KEWAUNEE NUCLEAR POWER PLANT
DOCKET 50-305
LICENSE No. DPR-43

RESPONSE TO REQUEST FOR ADDITIONAL INFORMATION RELATED TO
LICENSE AMENDMENT REQUEST 199 TO THE KEWAUNEE NUCLEAR POWER
PLANT TECHNICAL SPECIFICATIONS

REQUEST FOR ADDITIONAL INFORMATION CONCERNING
LAR 199 STEAM GENERATOR EDDY CURRENT INSPECTION FREQUENCY
EXTENSION

Figure 1
 SG – A Row 32 Col 84, FSI reported in 1R26.

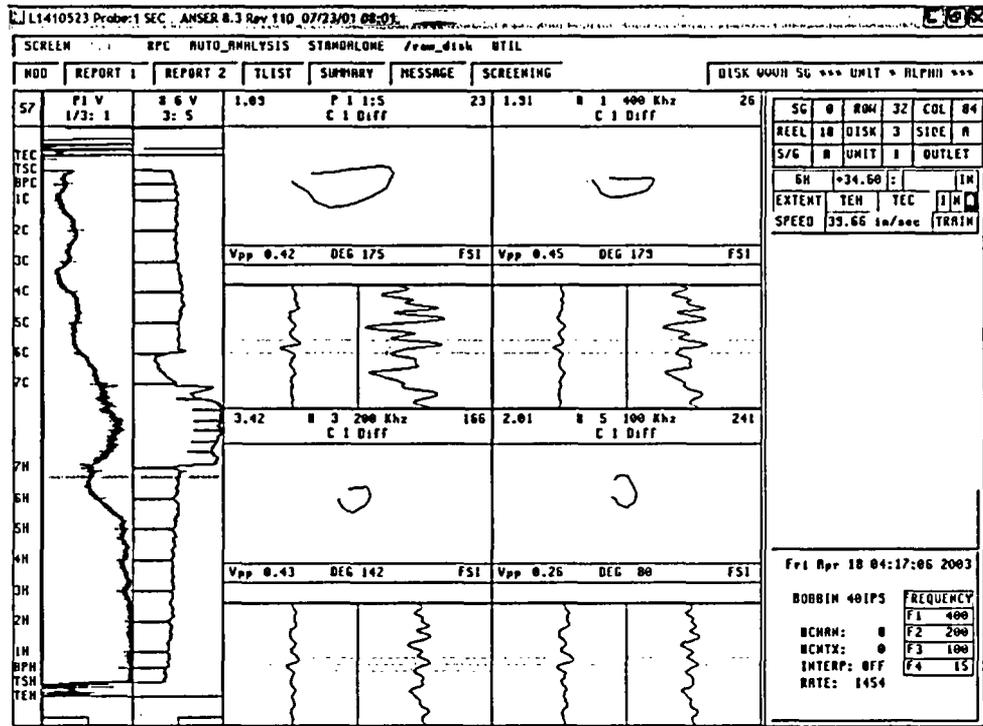
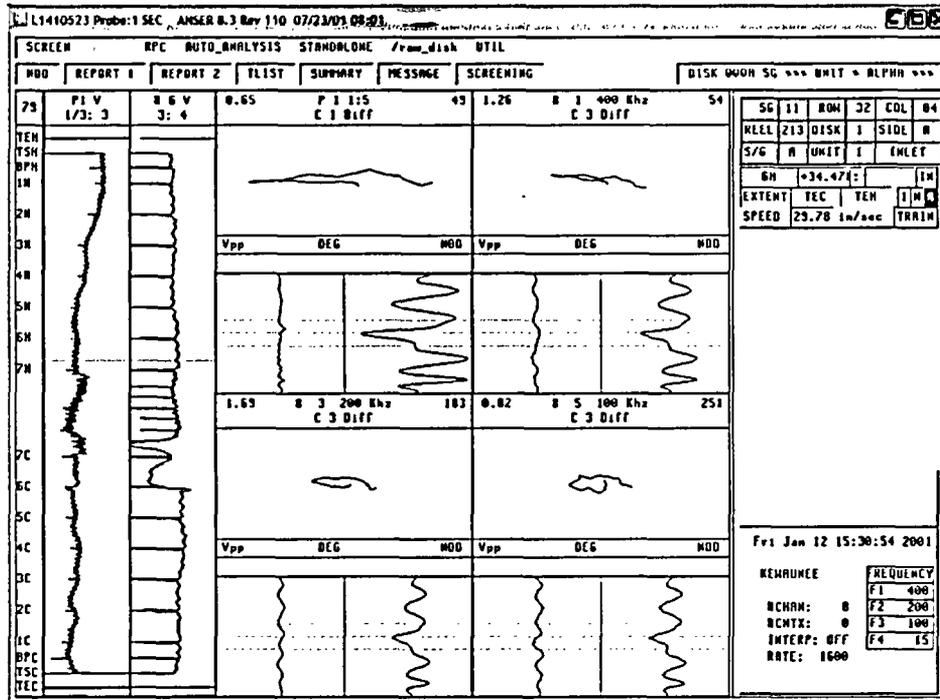
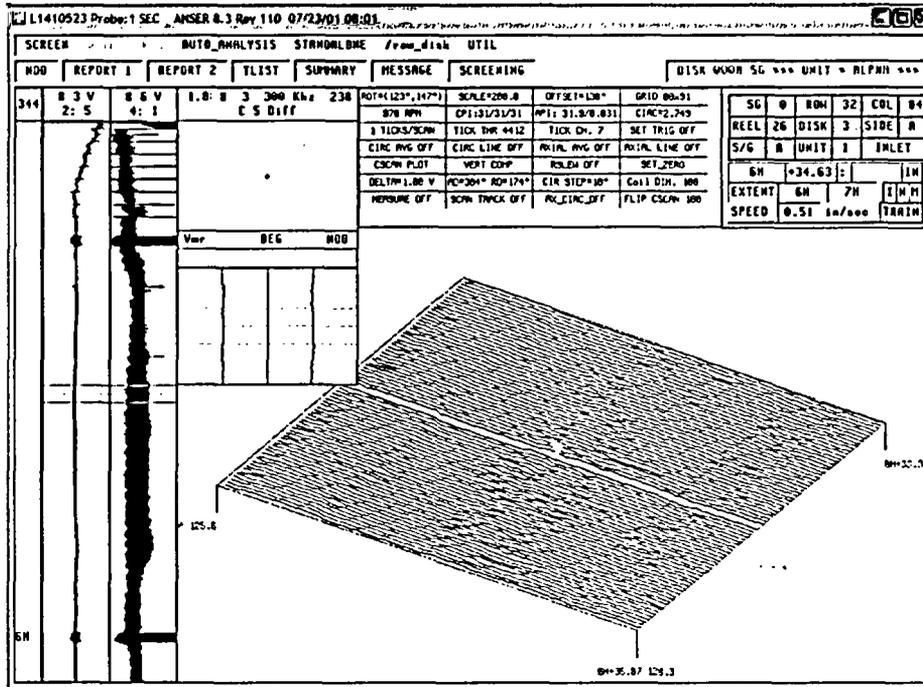
- a. In Attachment 8 to the licensee's letter dated August 6, 2003, (ML032250165), the licensee indicated that they detected two free-span indications (FSI). These indications either could not be detected in the preservice inspection or showed a change since the preservice inspection. Please, discuss whether the indications are new and/or changing. In addition, please discuss what is causing these indications to develop and/or change (i.e., could these indications affect tube integrity or be more susceptible to corrosion).

The two freespan indications (FSI) reported during the inservice inspection are shown in Figures 1 and 2. Both of these indications exhibit a change from the pre-service inspection (PSI) condition. The PSI results are shown in Figures 3 and 4. The PSI data for both of these locations exhibit low level geometric discontinuities which PSI are below the typical recording threshold. The amplitude of the FSI signals reported during the 2003 inservice inspection is commensurate with that of the discontinuities as is demonstrated by Figures 2 and 4. Also, note that the U-bend offset observable in the in-service data is not present in the pre-service data. The rotating probe inspections showed no detectable degradation (Figures 5 and 6). These signals are similar to those observed in Alloy 600 thermally treated (TT) tubing.

The history of the Alloy 600 TT tubing reveals a number of freespan indications that appear to be flaw-like on the bobbin probe and exhibit no degradation or small geometric discontinuities when inspected using a Rotating Pancake Coil (RPC). In the early operational history of Alloy 600 TT tubing, similar signals were reported and tubes were pulled to investigate the cause. No degradation was found. While no strong explanation for the change in the signals was established, it was concluded that they were benign in nature. It was postulated in the tube pull report that the change in the small ding signals is related to the same phenomenon that results in the U-bend offset.

These signals observed during the in-service inspection are considered to be benign in nature. Based upon Alloy 600 TT operating experience, no such indications have exhibited corrosion related degradation and represent no apparent increase in the susceptibility to corrosion over the base material surrounding the indication. They do not affect the integrity of the tube.

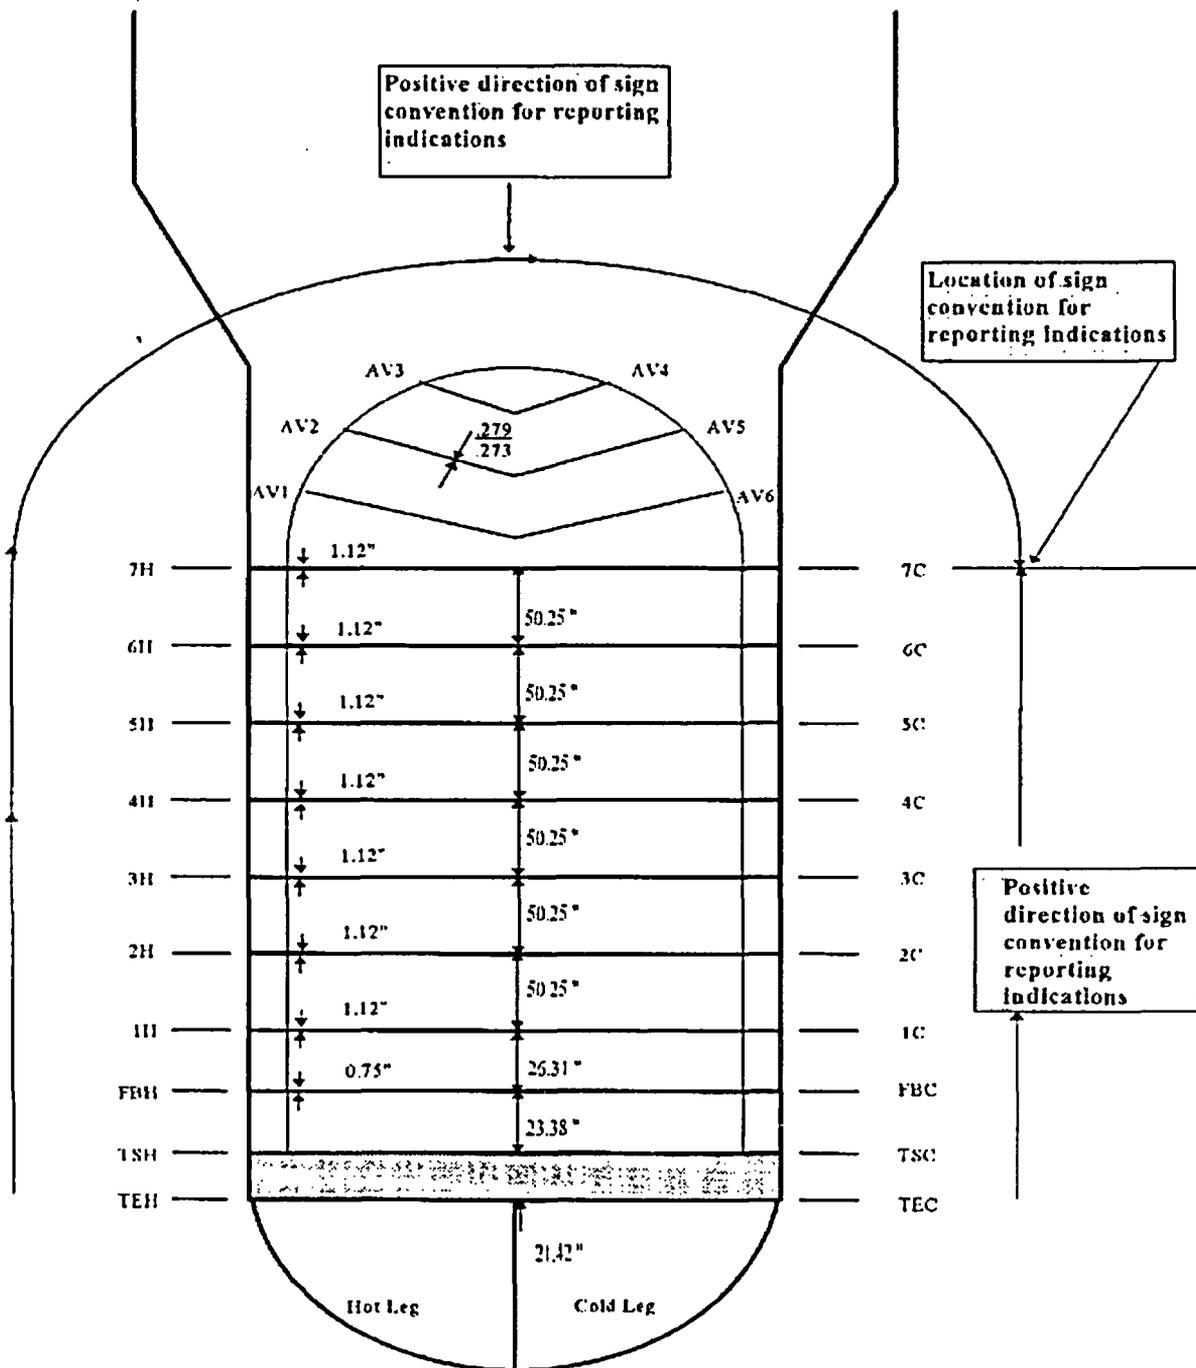
4. Please provide the following general information concerning your SGs:
 - a. Designer/ Manufacturer
 - b. Tube manufacturer
 - c. Schematic illustrating tube supports including naming conventions
 - d. Tubesheet map
 - e. Tube pitch (i.e., 1.1-inch triangular)

Response to 4c:
